Eugene A. Hickok and Associates, Inc.  
Hydrologists — Engineers

Re: St. Louis Park Groundwater Contamination Study

# MEMORANDUM NO. G18-9

TITLE: ST. LOUIS PARK GROUNDWATER CONTAMINATION STUDY -  
COLLECTION AND TREATMENT OF GRADIENT CONTROL WELL  
DISCHARGE

Figure 4

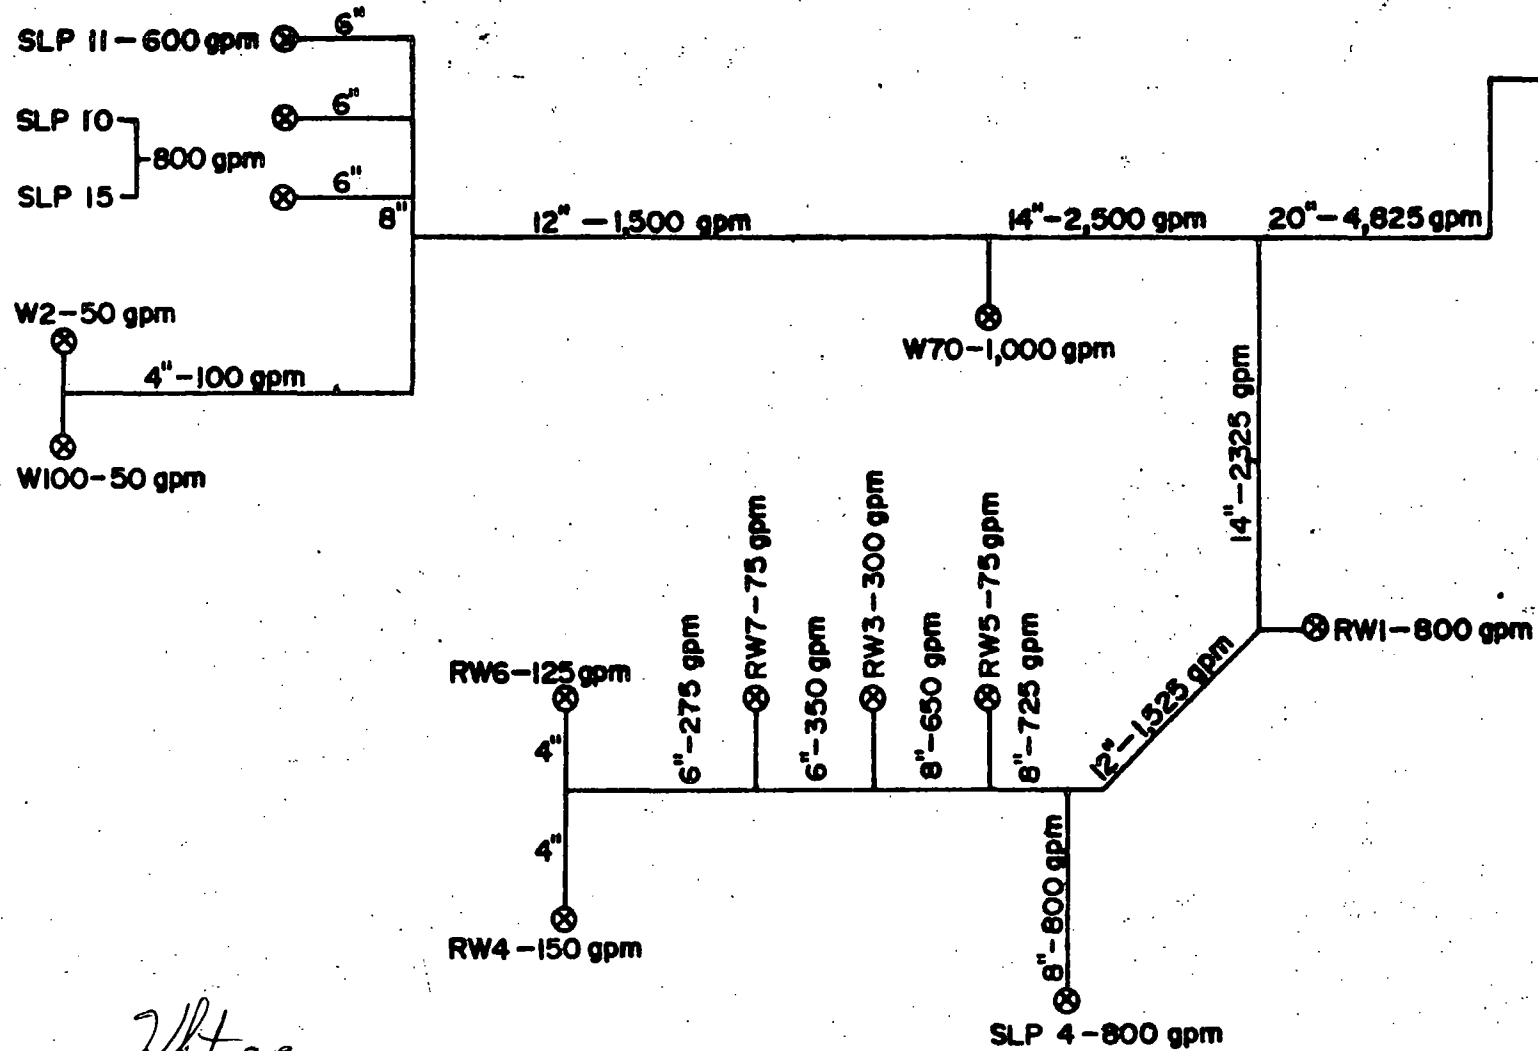
Alternative C was developed to dispose of all water to the Mississippi River with no treatment of any water. A schematic flow diagram of the piping required for this alternative is shown in Figure 4. *no lengths presented*

*What are  
pipe lengths required?*
